Service Bulletin

Subject: Engine Oil Consumption on Aluminum Block/Iron Block Engines with Active Fuel Management (AFM)
(Install AFM Oil Deflector and Clean Carbon from Cylinder and/or Install Updated Valve Cover)

This has been revised to add the 2010-2012 Chevrolet Colorado and GMC Canyon, RPO LH9 and update the Labor Operation to the Global Labor Code (GLC). Please discard Corporate Bulletin Number 10-06-01-008I (Section 06 – Engine/Propulsion System).

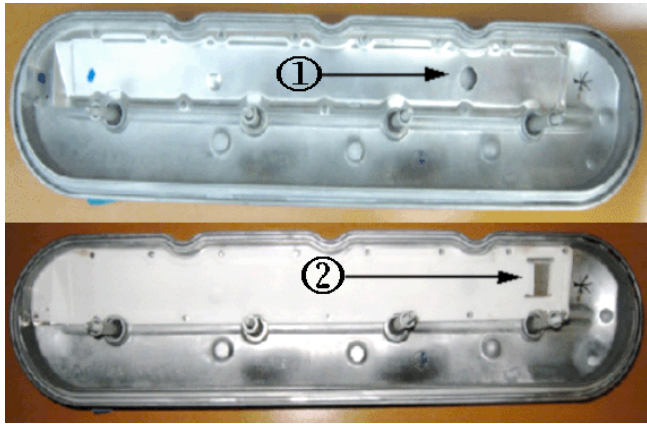
Aluminum or Cast Iron Block - Oil in Intake Manifold - Install Updated Valve Cover on All Models Built Prior to February 1, 2011

1) Old Design

2) New Design

PCV pullover or an overactive lifter can cause oil to be pulled through the PCV system even at low vehicle mileage. A correctly functioning PCV system will only leave a film of oil in the intake manifold. Inspect the intake manifold to see if there is any oil puddling in the bottom. If there is you will need to replace the left valve cover. Two new left rocker arm covers have been released for trucks and vans. Technicians should replace the left rocker arm cover with GM P/N 12570427 for 2007-2008 or GM P/N 12642655 for 2009-2011. Refer to the Parts Information below for the Camaro. This rocker arm cover has a relocated PCV drain hole that prevents oil from entering the intake manifold. Refer to Valve Rocker Arm Cover Replacement - Left Side in SI.

Note: These rocker covers are for specific years. The PCV orifice is different for each. The correct cover must be used or an SES light may set.

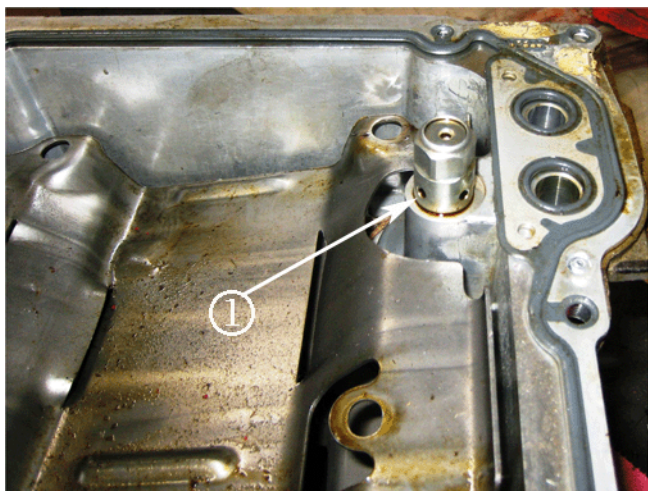
Aluminum Block - Oil Getting Past Piston Rings - Free Up Piston Rings and Install AFM Shield on All Non-Hybrid Models Built Prior to October 1, 2010 or all Hybrid Models Built July 7, 2009 - October 1, 2010

To correct this condition, install an AFM shield, perform the piston cleaning procedure as described in this document and install a new oil pan gasket per the procedure outlined in this document. Monitor oil consumption after this repair to ensure oil consumption has improved to acceptable levels.

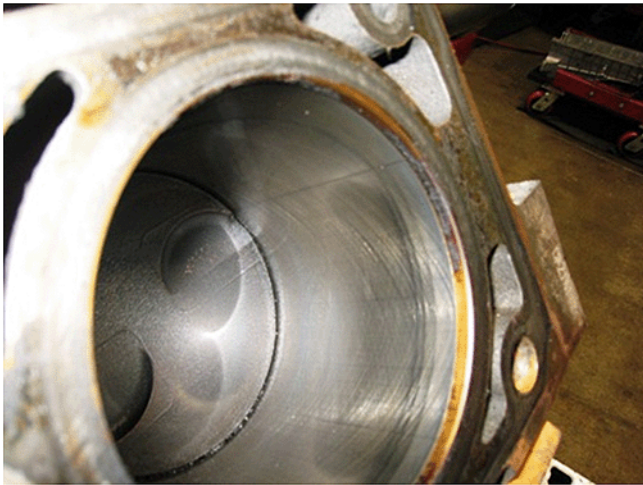
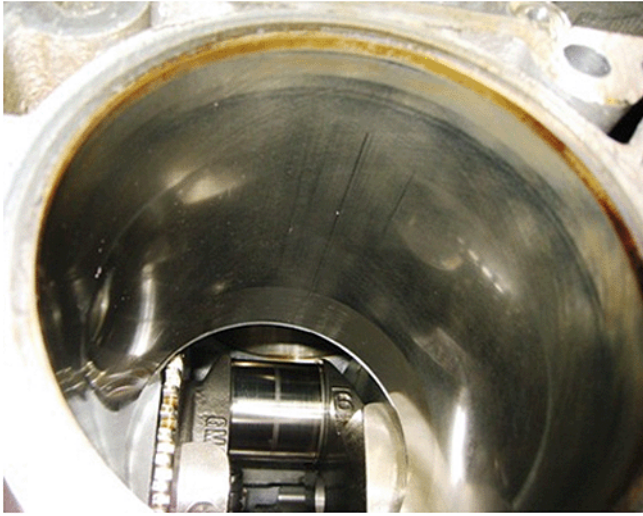
4. Remove the AFM valve (1).

5. Install the new shield (1), GM P/N 12639759, and tighten the AFM valve to the oil pan to 28 Y (20 lb ft).
